## **HINCKLEY NATIONAL RAIL FREIGHT INTERCHANGE**

### **The Hinckley National Rail Freight Interchange Development Consent Order**

### **Applicant's response to deadline 3 submissions [Part 9 - Noise]**

Document reference: 18.13

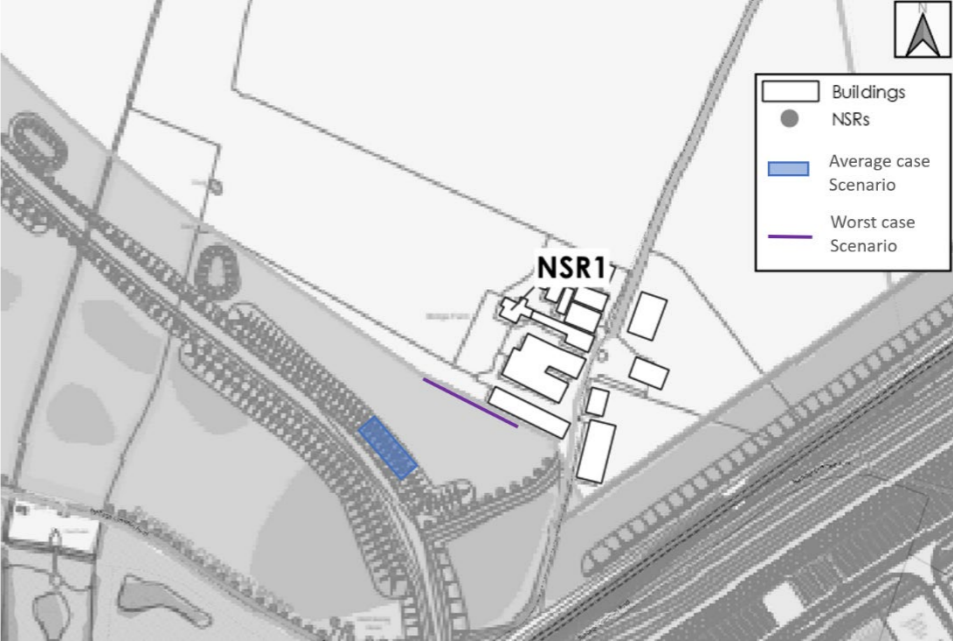
Response Number	Matter	Applicants Response
22	<p><b>Section 1. Failure to Determine Baseline Conditions</b></p> <p>In Section 1 of my Written Representation, which ran to 5½ pages, I described in detail how Tritax had taken the ambient (LAeq) noise levels they recorded at the Noise Monitoring Positions (NMPs) adjacent to the trackside (or roadside), and simply imposed them upon the Noise Sensitive Receptors (NSRs) without applying any attenuation to the ambient noise levels for the train pass bys, even though some of those NSRs are hundreds of metres away from the track (or road).</p> <p>I explained that this was a flagrant, fundamental and extremely grave failing that rendered very much of the remainder of Tritax’s Noise and vibration report invalid, that it contravened every relevant Acoustic Theory, was in breach of every British and International Standard, and also defied common sense. Those same remarks also applied to the maximum noise levels (LAmax,f ).</p> <p>For reasons of accessibility, in my Written Representation I adopted a descriptive rather than mathematical approach.</p> <p>In the latter part of Section 1, I also described in detail how Tritax had failed to indicate the distance at which the Noise Monitoring Positions (NMPs) had been placed away from the trackside (or roadside) and that the ambient (LAeq) and maximum (LAmax,f ) noise levels they recorded were dependent upon that distance, and so had no real meaning unless those distances were known. I explained that my observation of the site indicated that NMP4 was placed at no more than 12 metres from the nearside rail of the closest trainline.</p> <p>Finally, I outlined that once those distances were confirmed, it would be possible to calculate the actual ambient (LAeq) and maximum (LAmax,f ) noise levels at the NSRs from the NMP data already available from the Noise and vibration report.</p> <p>Tritax’s sole response to all of this was:</p> <p>“As set out in Table 10.1 of the ES Noise and vibration chapter, the noise monitoring methodology has been detailed within the technical note NTT2814 –Hinckley Survey Method Statement_Issue_P02 (document reference: 6.2.10.5, APP-184), which has been submitted to and agreed with Blaby District Council and Hinckley and Bosworth Borough Council – in both cases it was agreed by suitably qualified technical officers.”</p> <p>As you will see, Tritax did not engage with any of the points I raised. The Method Statement to which they refer (of which of course I was already aware) is purely a procedural document, that can have no sway upon the ambient (LAeq) and maximum (LAmax,f ) noise levels that NSRs actually experience. Also, Tritax do not indicate that they support the Method Statement, rather, their aim seems to be to pass a measure of responsibility for their Noise and vibration report to Blaby District Council and Hinckley and Bosworth Borough Council.</p>	<p>Further information to support the continued use of the measured ambient noise levels is provided specifically in pages 6 to 11 of the Written Statements of Oral Case ISH3 [Appendix F - Noise Assessment Update Note] (document reference: 18.7.6, REP3-061).</p> <p>Essentially, within that document, the NMP4 measurement data was compared against DEFRA strategic noise mapping and found that, with increased distance from the rail line moving north, receptors experience increased road traffic noise and therefore for NSRs represented by NMP4, the ambient noise levels from the mapping align with those used.</p>
